Access Compliance Report

Public Rights-of-Way

(Curb Ramps)

Intersection ID: 10038746	Main Street: STATE_ST	Cross Street: N/A	Location: N
ADA ID: E67C014BE1D4	Ramp Type: BlendTrans2	Initial Pass/Fail: Fail	Overall Compliance: No
		Severity Score: 12.5

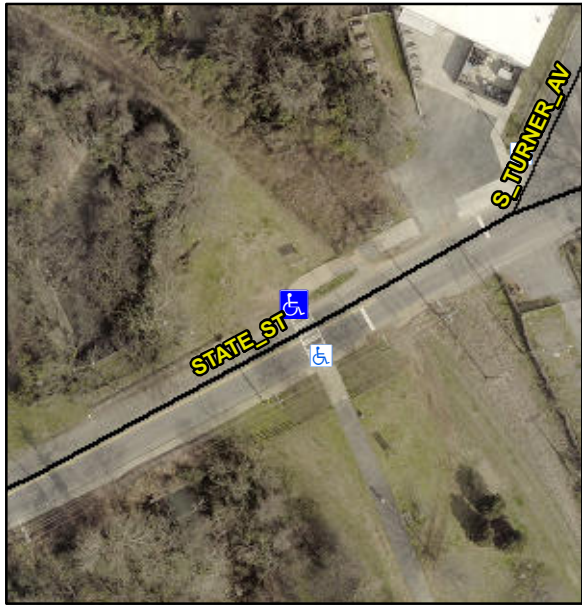
Codes/Mitigation Info/Possible Solution			Field Measurements/Component Compliance					
	Possible Solutions:		Compliance	Description	Data	Compliance	Description	Data
	Remove & Replace Curb Ramp With Two New Directional Ramps or Equivalent.		N/A	Ramp Length (in)	44.0	Yes	BlendTrans Slope (%)	0.0
			Yes	Ramp Width (in)	115.0	No	BlendTrans XSlope (%)	5.3
			N/A	Flare Type LT	N/A	N/A	Flare Type RT	N/A
			N/A	Flare Slope LT (%)	N/A	N/A	Flare Slope RT (%)	N/A
			N/A	Flare Traversable LT?	N/A	N/A	Flare Traversable RT?	N/A
			N/A	Landing Length (in)	N/A	N/A	DWS Provided?	N/A
			N/A	Landing Width (in)	N/A	N/A	DWS Contrast?	N/A
			N/A	Landing Slope (%)	N/A	N/A	DWS Length (in)	N/A
			N/A	Landing X Slope (%)	N/A	N/A	DWS Full Width?	N/A
<p>Surveyor Notes:</p> <p>N/A</p> <p>PROW/ADA:</p> <p>R304.5.3</p>			N/A	Landing Curb? (Y/N)	N/A	N/A	DWS Offset (in)	N/A
			N/A	Shared Landing?	N/A			
			N/A	Gutter Ponding?	N/A	N/A	Gutter Slope (%)	N/A

N/A	Gutter Lip Ht (in)	N/A	N/A	Gutter X Slope (%)	N/A
			N/A	Painted X Walk1?	Yes	N/A	Painted X Walk2?	N/A
				X Walk 1 Direction	To SE		X Walk 2 Direction	N/A
				X Walk 1 Width (in)	112.0		X Walk 2 Width (in)	N/A
				X Walk 1 Slope (%)	1.5		X Walk 2 Slope (%)	N/A
				X Walk 1 X Slope (%)	5.0		X Walk 2 X Slope (%)	N/A
			N/A	Ramp inside XWalk1?	Yes	N/A	Ramp inside XWalk2?	N/A
<p>Total Cost: \$ 3200.00</p>				Road Slope (%)	5.0		Clear Space?	N/A
				Road X Slope (%)	1.5	N/A	Clear Space to XWalk (in)	N/A
			N/A	Any Obstructions?	N/A	N/A	Storm Grate/Utility Hazard?	N/A
				Obstruction Type			Storm Grate/Utility Type	
					N/A			N/A
						Yes	Surface Condition? (G/P)	Good
						N/A	Curb Slope (%)	N/A
